ADDENDUM

Date Issued:	Feb 17, 2023
Project:	Intermountain Healthcare LDS Hospital, Fluoro Room 2 Remodel 8 th Ave., C Street Salt Lake City, UT 84143
Addendum Number:	1

LDS Hospital
Fluoro Room 2 Remodel

1 Addendum 01

Floor Plan Lower Level

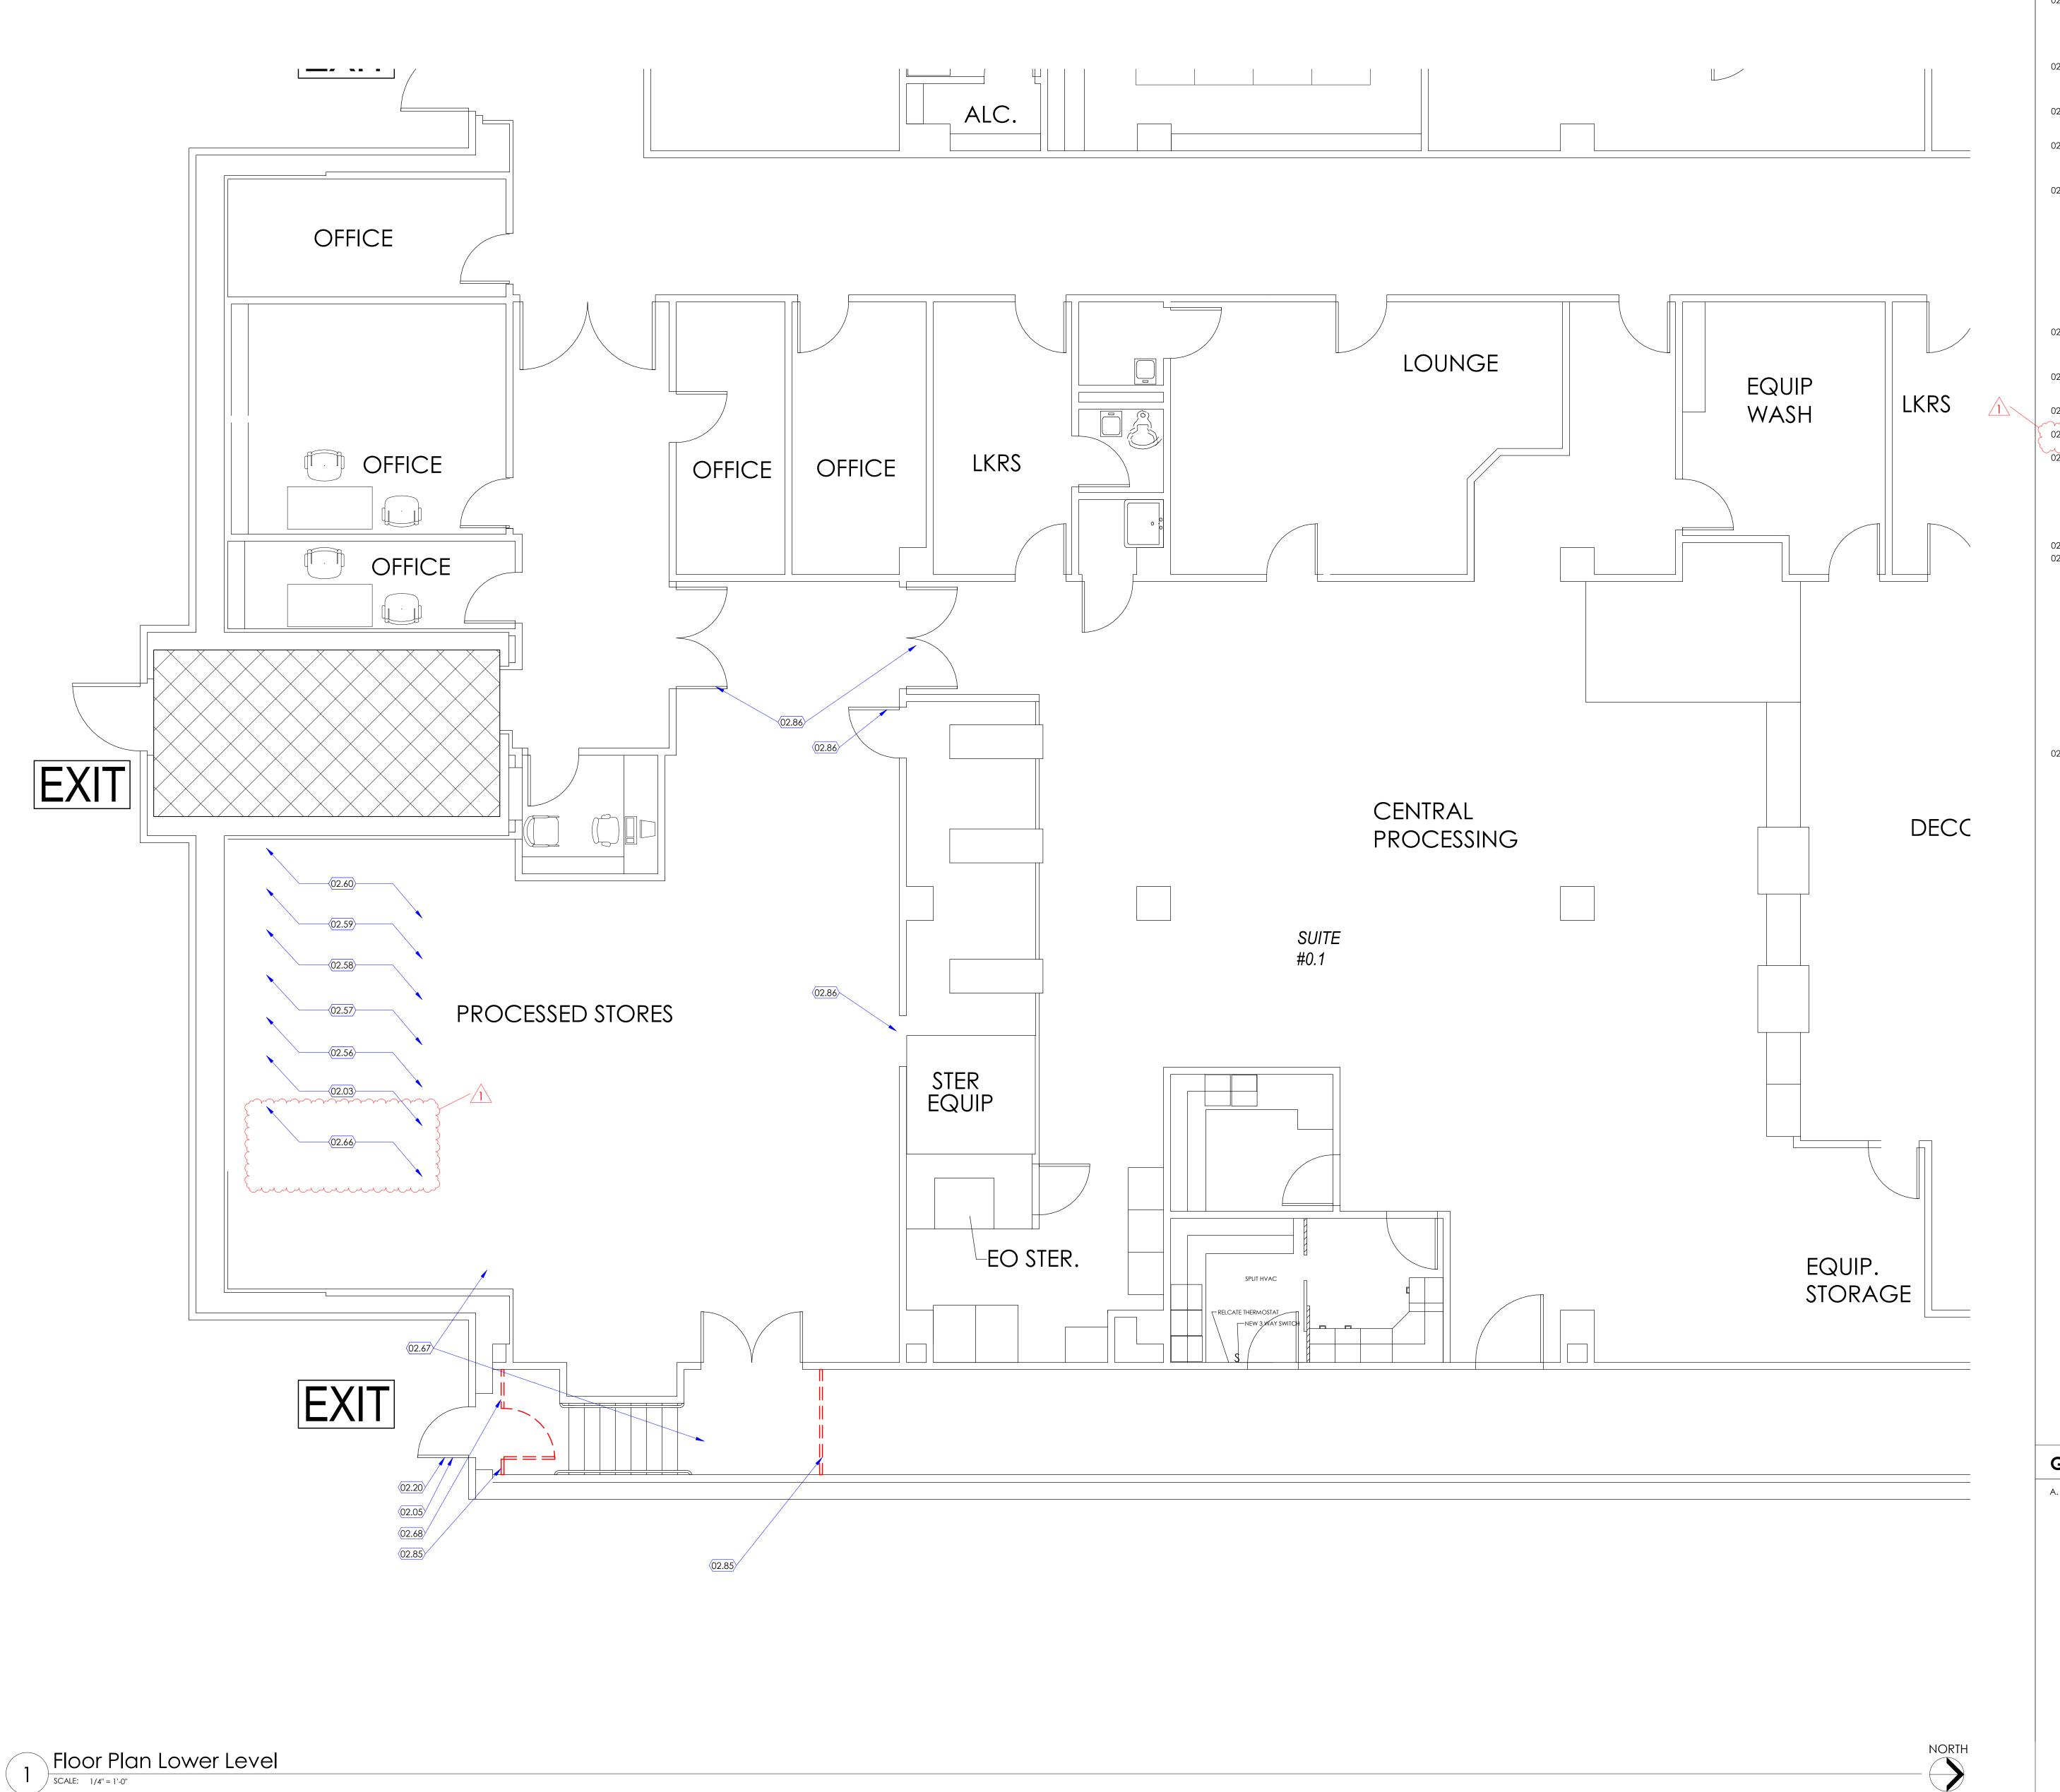
Item Number	General Items Description
1	Per Robert Smith (Intermountain Health), the conduit run between the Fluoro Room 2 and the panel that serves it, is 2". Add Alternate #2 would have upsized this conduit run if undersized but 2" is adequate for the new circuitry. As such, delete any references to Add Alternate #2. New circuitry for electrical disconnect shall remain as part of base bid. See electrical drawings.
2	Sheet A112, add keynote 02.66.
3	Sheet A113, revise keynote 01.59.
4	Specification Section 01 23 00, delete Add Alternate #2.

02.60 TIGHTLY SEAL EXISTING TRANSFER AND SUPPLY AIR GRILLES WITH PLASTIC. SEAL
- 02.66 WHERE FIREPROOFING IS REMOVED OR DAMAGED AS A RESULT OF THROUGH
 BOLT INSTALLATION, PATCH AND REPAIR FIREPROOFING AS REQUIRED.
